BENTLEY MARK VI

COLUMN GEAR CHANGE(LEFT-HAND DRIVE CARS)FOR INFORMATION:

An alteration to the column gear change mechanism has been introduced replacing the early type gear change cross tube assemblies (2 off) and the gear change pull rod assembly by two new cross tube assemblies and one pull rod assembly having keyhole type sockets.

The new parts were incorporated on Chassis No.B-281-LGT and all subsequent left-hand drive cars.

FIG. 1. DESIGN DIFFERENCES - REAR END.

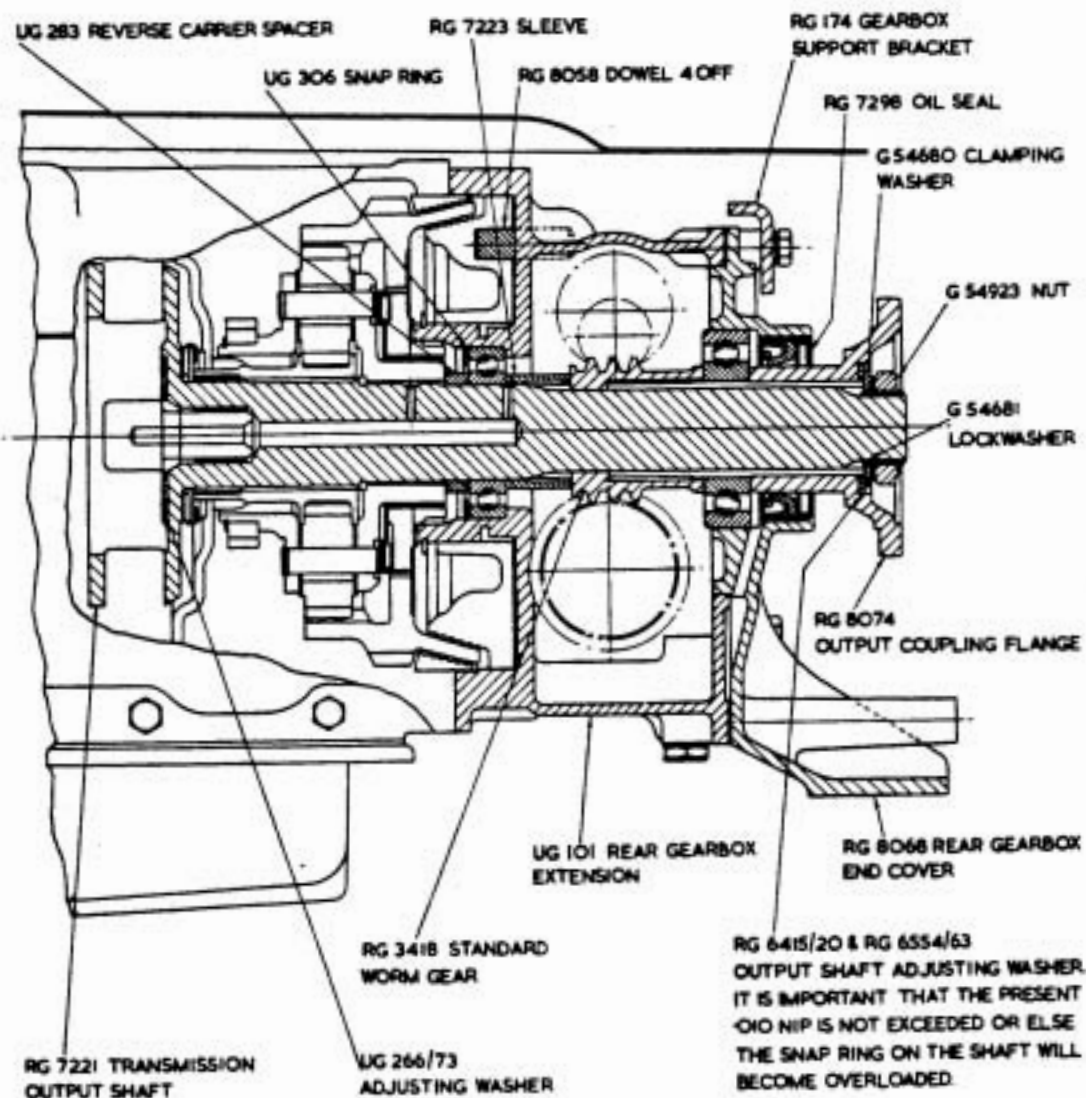
The main differences are embodied in the rear extension of the gearbox (see drawing attached) where the parts of Bentley design are shown in section. Original Hydra-Matic parts are shown in outline only.

The rear extension casting has been re-designed to incorporate the Bentley wheel-brake servo motor, ride control pump, speedometer drive gear, and gearbox output shaft, on which the reverse epicyclic unit from the original Pontiac rear extension is mounted. The ride control pump, which provides variable damping to the rear shock absorbers, employs Automatic Transmission fluid taken from the gearbox sump by means of a pipe through the orifice normally used in 1952 G.M. cars for "under-hood" gearbox filling. The filling of the Bentley Automatic Gearbox is, therefore, carried out through the dipstick orifice.

The throttle-valve linkage has been re-designed to give slightly altered upshift characteristics. The manual control lever on the steering column, and the operating linkage, the starter ring, flywheel and divided bell housing are also of Bentley manufacture.

FIG.1 THE FLEXIBLE PIPE RE-POSITIONED.

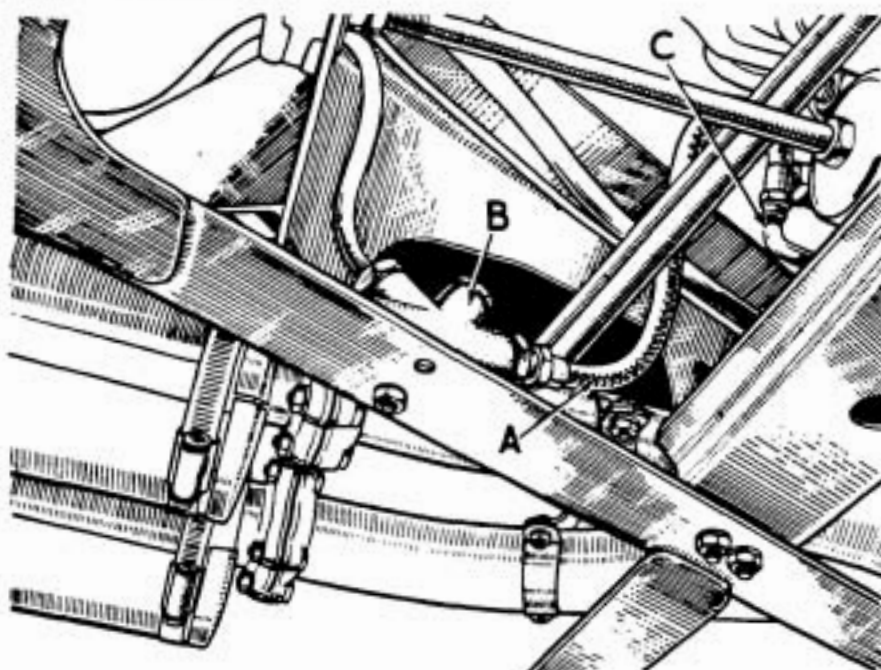
Experience has shown that, on the left hand drive Bentley 'R' Type fitted with an Automatic Gearbox, the flexible pipe from the ride control pump to the four-way union mounted on the frame cruciform member just behind the gearbox, can be burnt by fouling the exhaust pipe. In exceptional cases this may lead to considerable loss of oil from the gearbox, which, although causing no permanent damage, will give rise to immediate erratic and noisy operation. A shorter pipe, Part No. RF.9971, has been fitted on production on chassis No. B-20-UN and from B-26-UN onwards.

Retailers should check all left-hand drive 'R' Type Bentleys, fitted with an Automatic Gearbox, in their area at the earliest opportunity on service and if necessary, reposition the flexible pipe as described below.

- A. Repositioned Flexible Pipe. C. L-Shaped Outlet Pipe.
B. Four-Way Union.

FIG.1 EXPLODED VIEW OF
RIDE CONTROL
PUMP.

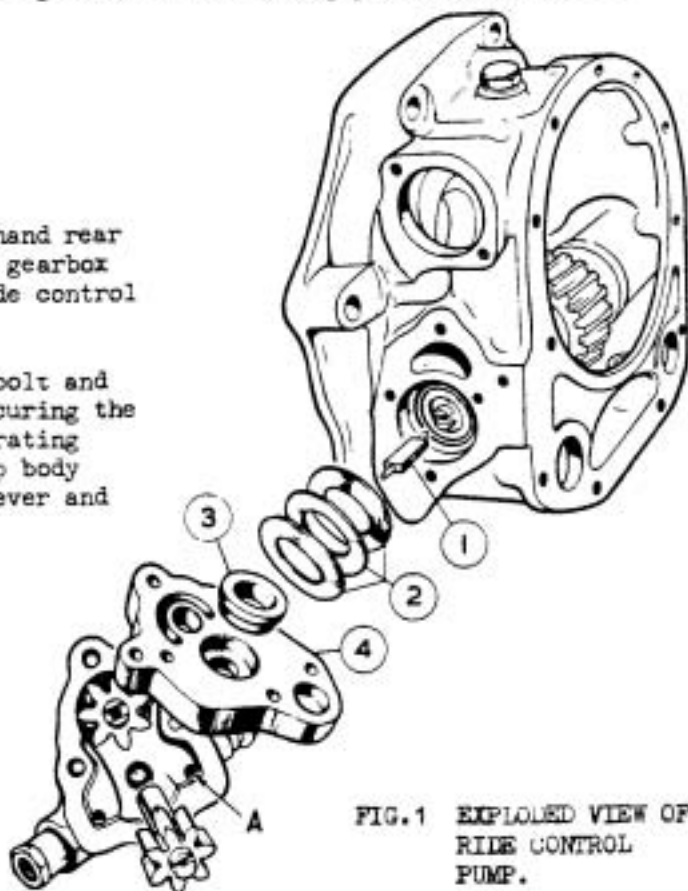
This Bulletin details the method of correction and incorporates a modification for increasing the diameter of the pump intake passage, which further improves its operation.

- (viii) The pump intake passage is shown at A Fig.1. The drilling should be increased from .250" (6.3 mm) to .343" (8.7 mm). First enlarge the hole with a 5/16" drill and then with a 11/32" drill. In order that the drill may enter centrally, the shoulder on the pump flange may be relieved with a round file. Care must be taken to ensure that the drill does not protrude too far beyond the end of the drilling to damage the threads for the control valve rod nut.
- (ix) Remove all traces of swarf.

FIG. 2 ADJUSTING THE TIE-ROD LENGTH.

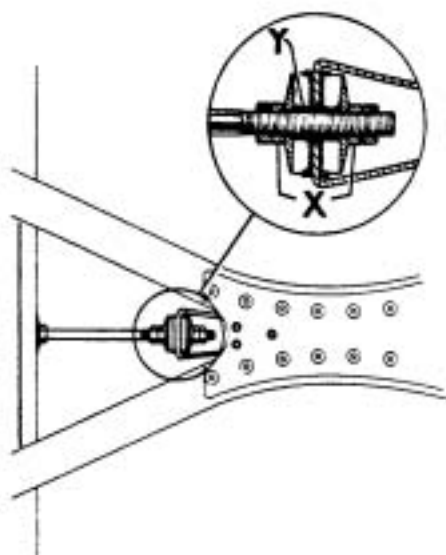
Details of both modifications are set out in this Bulletin and Retailers are asked to incorporate them on a Category 2 basis, dealing with cars as they come in for service.

- (iii) Drill out the existing rivet securing the bracket to the lower cruciform stiffening plate (Fig.1). Enlarge the hole to .375" (9.52 mm) dia. Fit the bolt and stiffening plate. The stiffening plate fits between the bolt head and upper face of the bracket.
- (iv) Fit the new rubber seating and backing plate (Fig.1).
- (v) Discard the old rubber seating and refit the tie-rod.
- (vi) To adjust the length of the rod, screw up the adjusting nuts (X Fig.2) finger tight and then tighten them an equal amount until the distance piece Y is clamped. Tighten the locknuts. The adjustment should impose no fore and aft deflection on the gearbox rear rubber mounting block.

VIEW LOOKING FROM FRONT OF CAR SHOWING
MODIFICATION TO EXISTING TIE ROD BRACKET

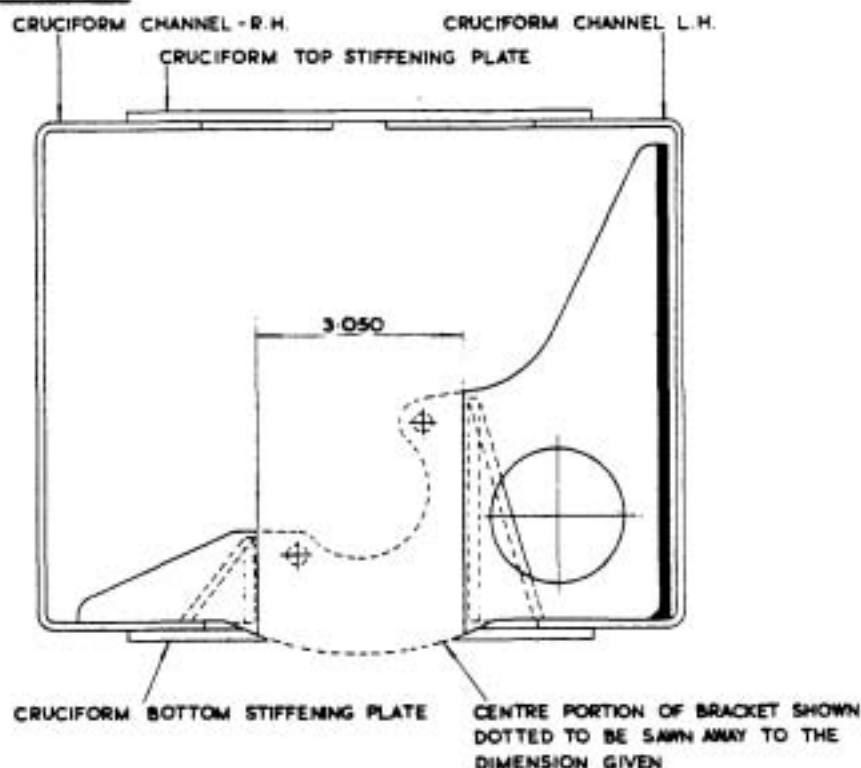
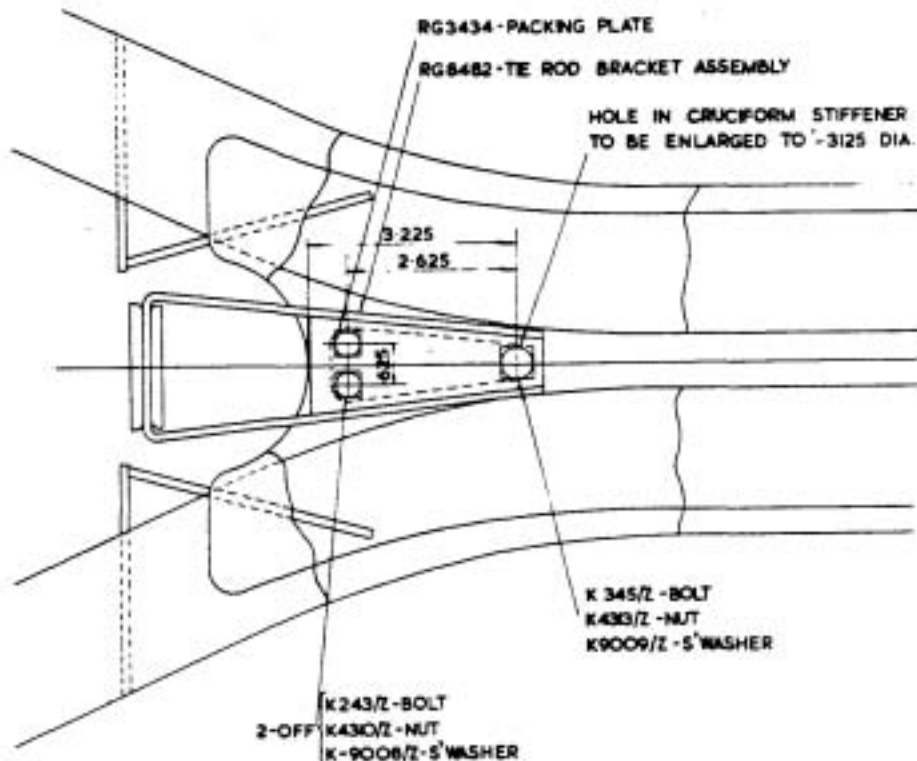
- (i) Place the car on a ramp or over a pit.
- (ii) Remove the gearbox tie-rod by removing the two nuts and spring washers retaining the rubber seatings to the gearbox at the front end and to the mounting bracket at the rear end.
- (iii) Cut out the centre portion of the transverse mounting bracket with a hacksaw as shown in Fig.3. Clean up and paint the cut edges.

- (iv) Increase the diameter of the rear centre hole in the cruciform bottom stiffener plate from $\frac{1}{4}$ " (6.35 mm) to $\frac{5}{16}$ " (7.93 mm) (Fig.4). On some frames the three holes in the stiffening plate may not already exist and should be drilled in accordance with the dimensions given in Fig.2.
- (v) Fit the new bracket and packing piece to the top of the stiffening plate securing with the three bolts, spring washers and nuts.
- (vi) Remove the old rubber seating from the rear end of the tie-rod and refit the rod to the gearbox and bracket.
- (vii) Set the length of the rod as in para 2 sub.para (vi) above.

FIG. 3 TO MODIFY THE THIRD MOTION SHAFT
RG. 5469 to RG. 8530.

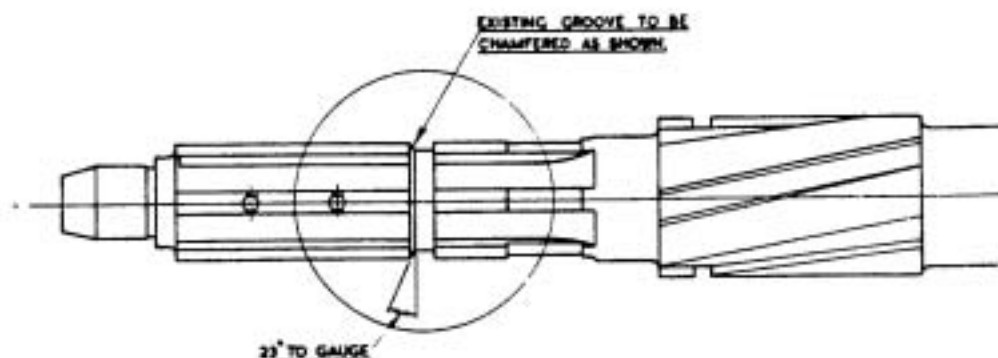
RG.8529 Thrust Washer-3rd Motion Shaft	1 Off
RG.8530 3rd Motion Shaft	1 Off
or RG.5469 modified to RG.8530 (Fig.3)

The chamfer on the front face of the groove in the third motion shaft should be ground off if necessary using the thrust washer itself as a gauge. The washer should rotate freely in the groove but endfloat must not exceed .004" (.10 mm).

FIG. 4 TO MODIFY 3RD MOTION SHAFT
RG. 5469 to RG. 8472

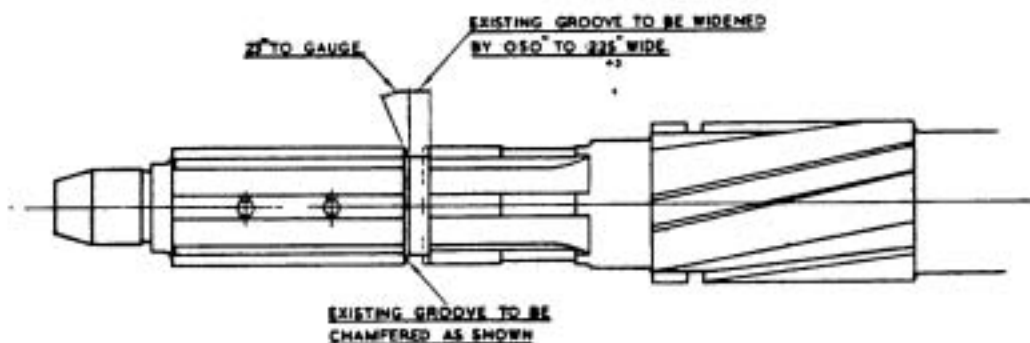
RG. 8473	Thrust Washer-3rd Motion Shaft	1 Off
RG. 8472	3rd Motion Shaft (or RG. 5469 modified to RG. 8472 - Fig. 4)	1 Off
RG. 8459	3rd Speed Gear (or RG. 100 modified to RG. 8459 - Fig. 5)	1 Off
RG. 8461	Sleeve - 3rd Motion Shaft (or GB. 5374 modified to RG. 8461 - Fig. 6)	1 Off
RG. 8467	Sliding Piece - 3rd Motion Shaft (or RG. 5470 modified to RG. 8467 - Fig. 7)	1 Off

The machining operations are detailed in Figs. 4, 5, 6 and 7. The sleeve RG. 8461 may be turned in a lathe using a carbide tipped cutting tool but other parts should be ground. The machining of the 3rd speed gear requires an internal grinding machine.
